**CERTIFICATE OF APPROPRIATENESS**

**Property:** 518 W. 12<sup>th</sup> Street, Tracts 34A, 35A, and 36A, Block 205, Houston Heights Subdivision. The property includes a historic 980 square foot, one-story wood frame single-family residence and a detached garage situated on a 4,400 square foot (44' x 100') interior lot.

**Proposal:** Alteration – Construct a rear 1 and 2-story addition to a contributing one-story residence

**HAHC Action:** Approved

**EAST SIDE ELEVATION**

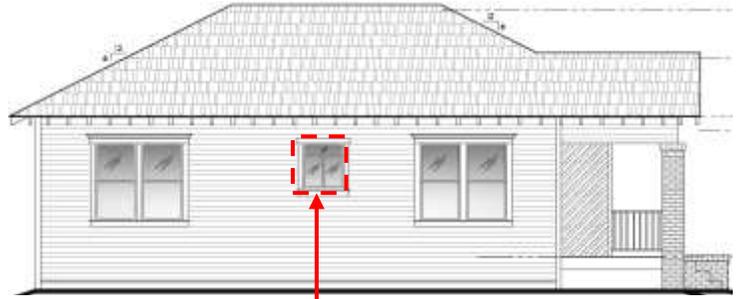
*Non-original aluminum box window*

*Proposed 1-over-1 wood sash window*

**Side Elevation:** Replace an existing non-original aluminum box window with a 1-over-1 wood sash window; the opening will not be modified.  
**(East)**

**WEST SIDE ELEVATION**  
EXISTING

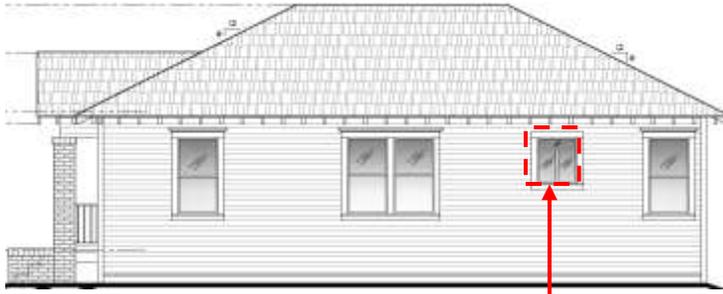
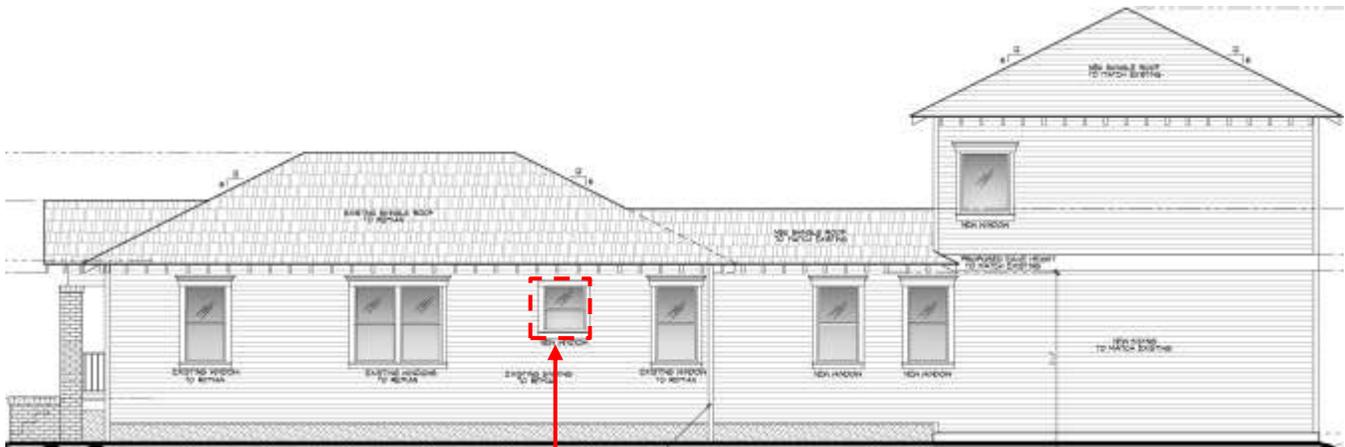
*Non-original aluminum box window*

*Proposed 1-over-1 wood sash window*

**Side Elevation:** Replace an existing non-original aluminum box window with a 1-over-1 wood sash window; the opening will not be modified.  
**(West)**
